**E.1.a.c 1150 Cook Street: Development Permit with Variances
Application No. 00130**

Council received a report dated November 12, 2020 from the Director of Sustainable Planning and Community Development regarding a proposal to construct a 16-storey, mixed-use building with ground-floor retail and residential above, including approximately 129 dwelling units.

Project
**Commercial / Residential Development
1150 Cook Street
Victoria, BC**

Sheet Title
East & North Elevation

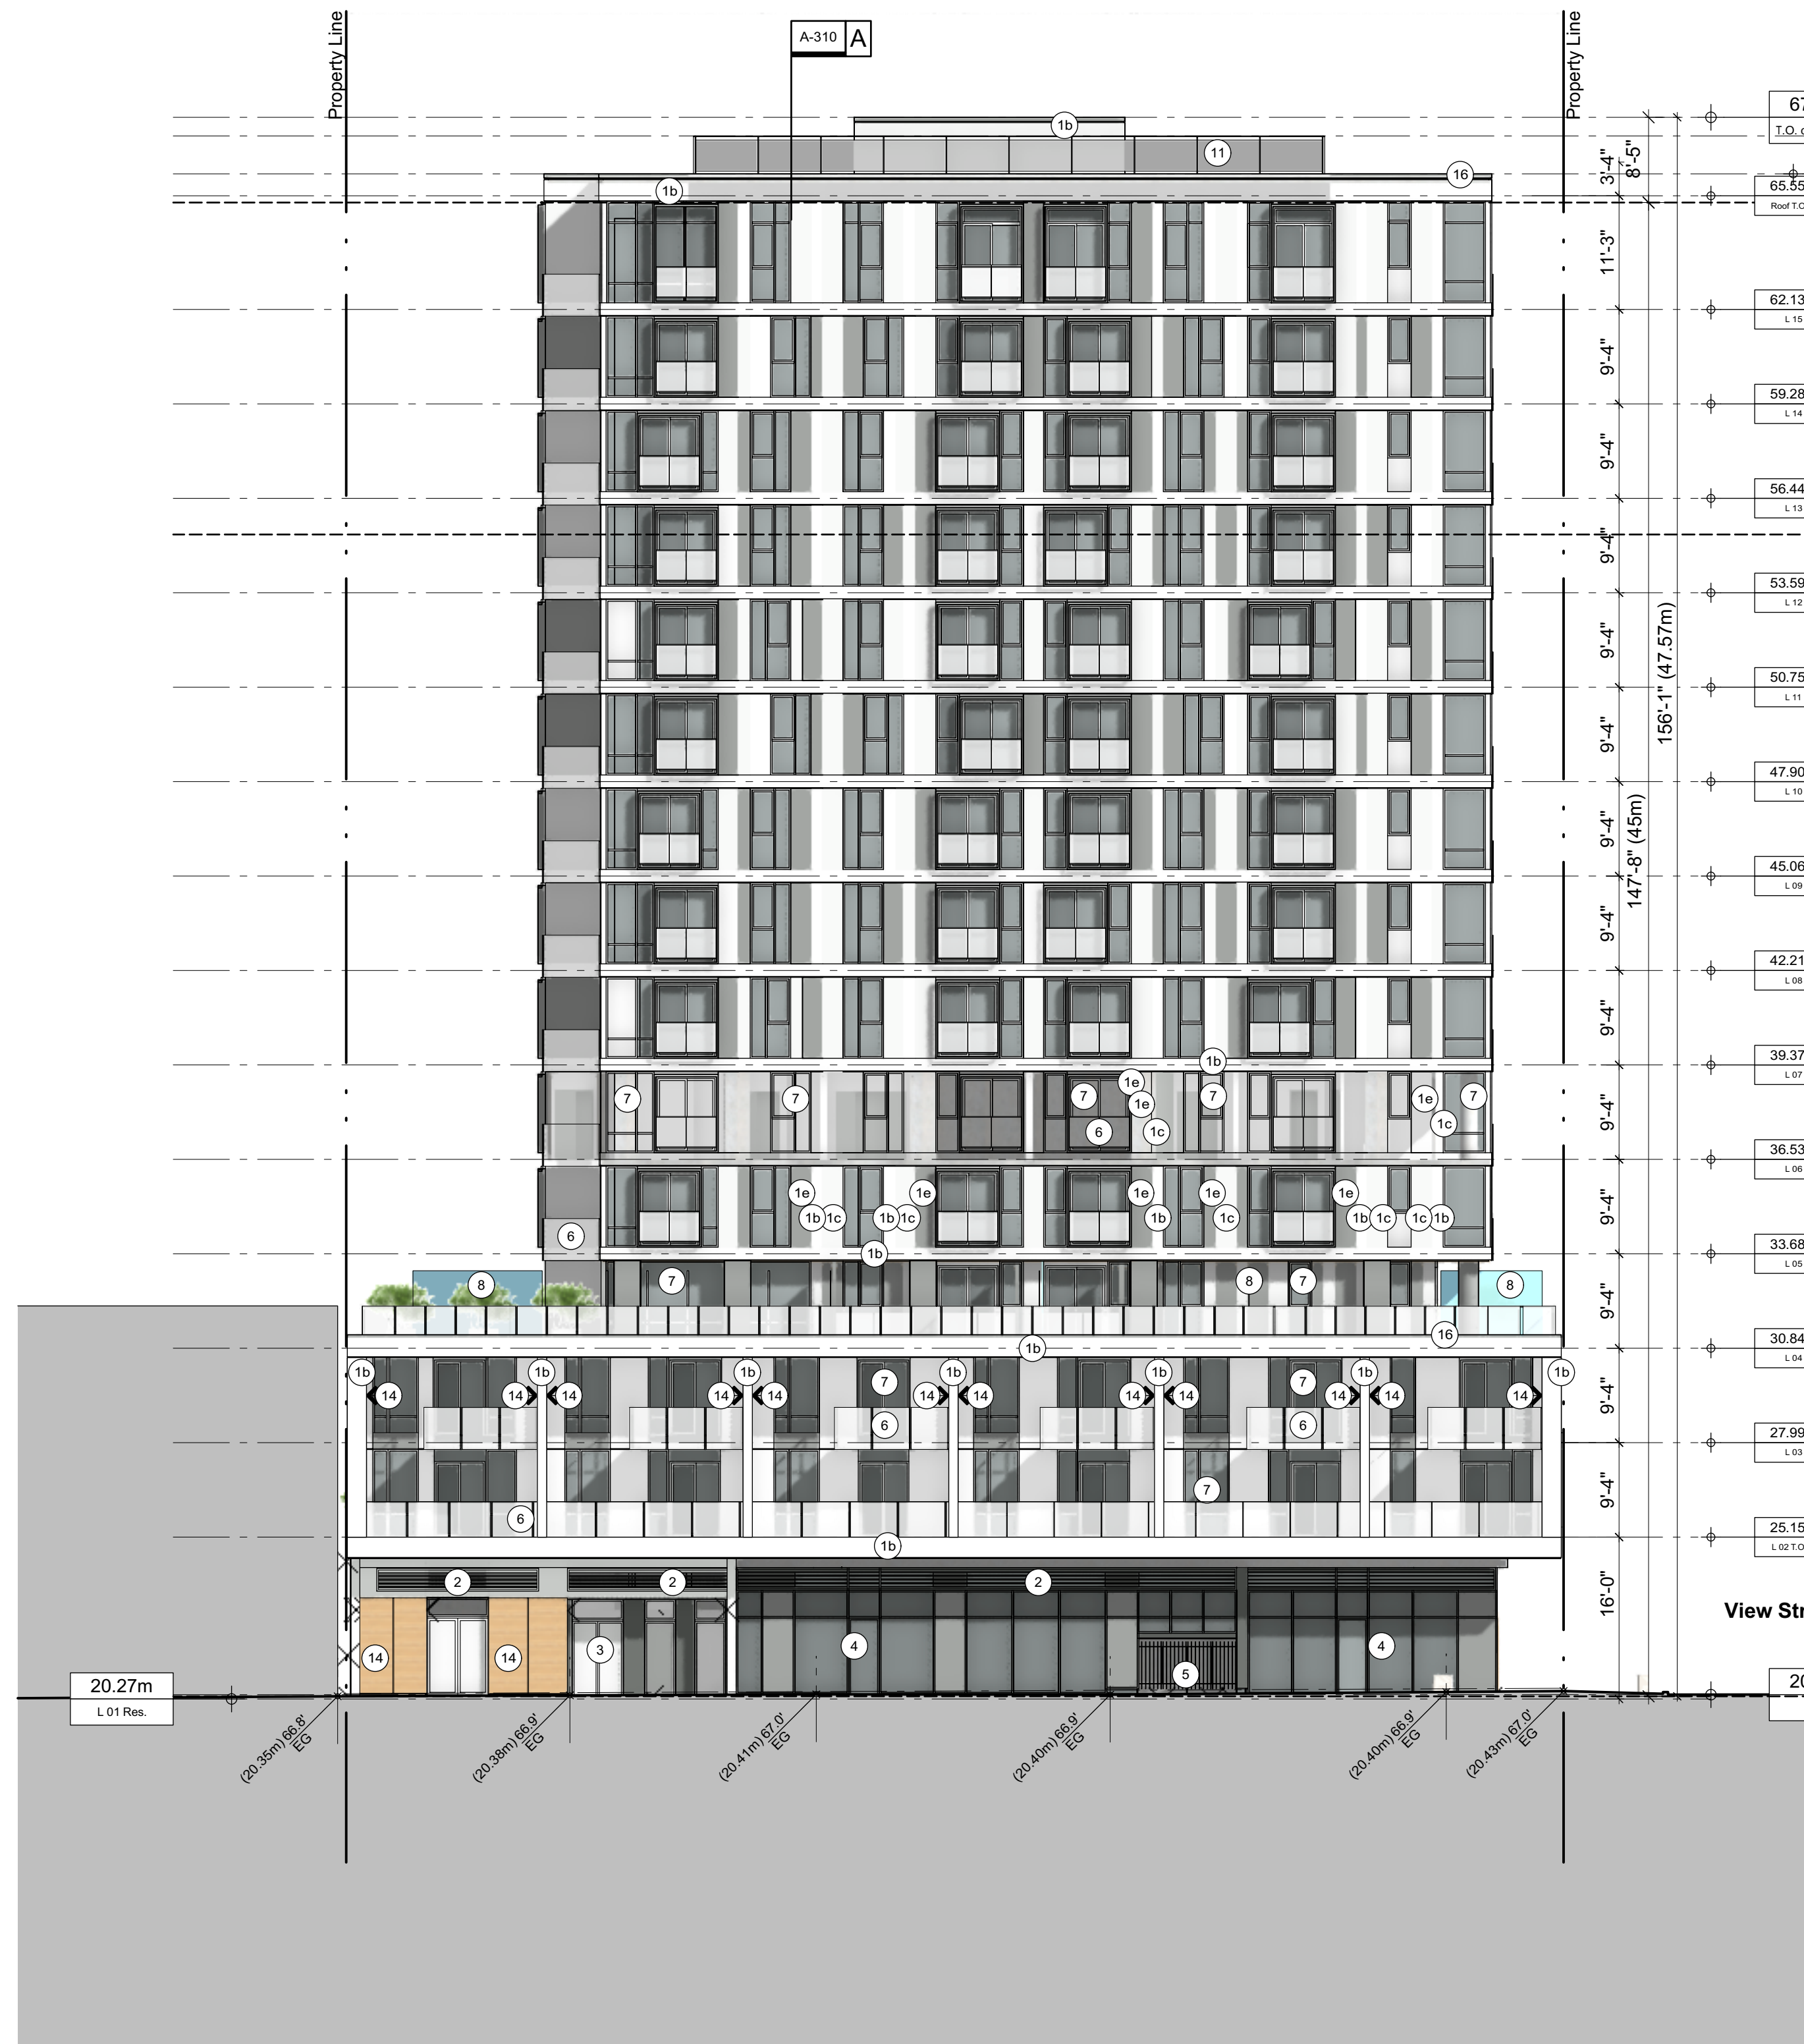
- a. Further consideration for the location of the gas meter on Cook Street and provision of additional detail for the design of the metal fence enclosure, to the satisfaction of the Director of Planning.

New buildings should be designed to relate well to public streets and sidewalks and have quality architectural materials and detailing in building bases and street walls. Staff have noted the limited and inconsistent detail provided on the architectural elevations, renders and material sheet, and recommend that these items be corrected prior to the application being considered for an Opportunity for Public Comment. In particular, the site plan indicates a gas meter that occupies a prominent location on the Cook Street frontage, with “decorative metal gates” but insufficient detail has been included on the elevations to fully review this aspect of the design. Staff recommend the location of the gas meter be reevaluated to ensure a positive street relationship along Cook Street.

LANDSCAPE PLAN

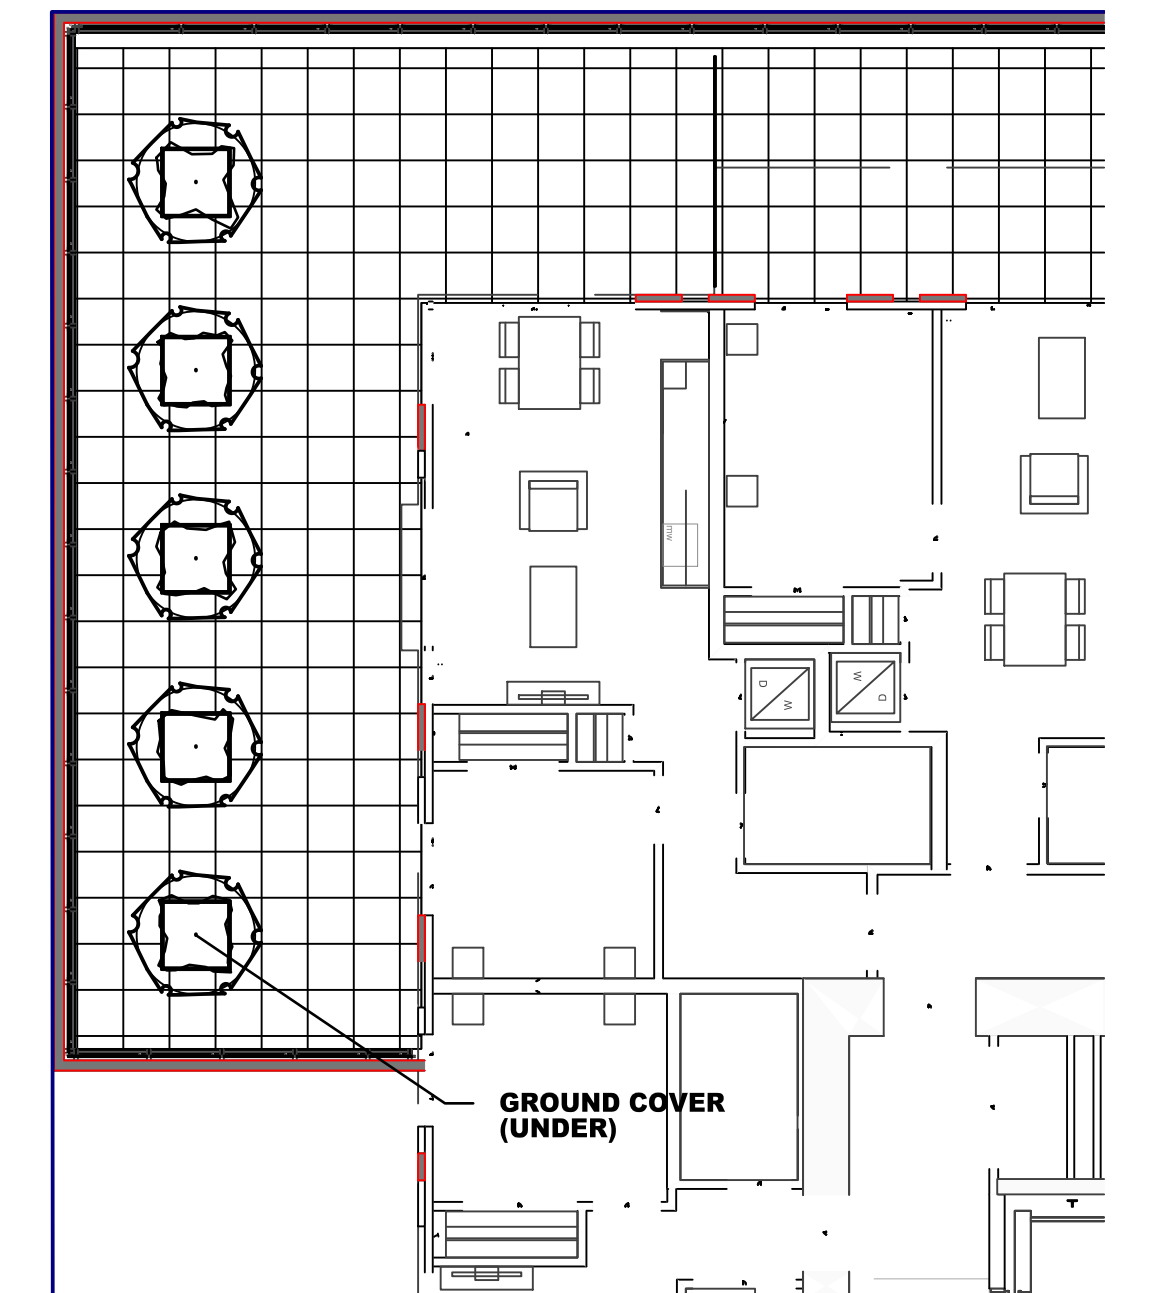
- d. Corrections to satisfy Parks requirements and to resolve inconsistencies with the site plan, landscape plan and building cross sections as they relate to landscaping and street trees, to the satisfaction of the Director of Parks, Recreation and Culture.

The applicant is proposing to plant three municipal trees in grates (consistent with standard practice) on the View Street frontage and one new tree on Cook Street boulevard. The new boulevard tree has not been shown on the drawings but has been included in the Tree Impact Summary table below.

Picture #4: The red line indicates the location of the balconies and the minimum amount of canopy loss. 60cm of clearance from the building would result in pruning cuts made at or behind the property line (blue line).

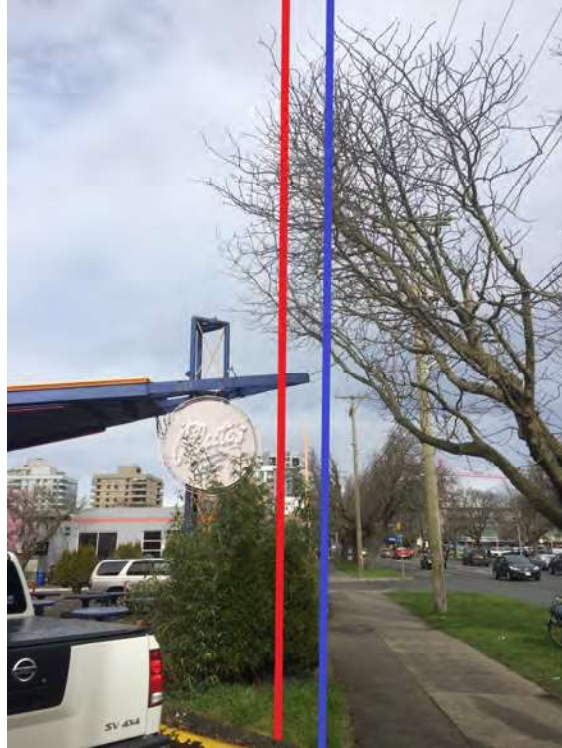
- e. Design revisions to reduce the impacts on the street trees along Cook Street, including reducing the pruning within the canopy and within the critical root zone to ensure the successful retention of these trees, to the satisfaction of the Director of Parks, Recreation and Culture.

There are two mature horse chestnuts on the Cook Street boulevard proposed for retention. The proposal, as currently shown, would require substantial pruning to the canopy of one large (70cm DBH) healthy horse chestnut tree growing on the Cook Street boulevard to construct the proposed building. The above-ground portion of the building is planned to have a setback of
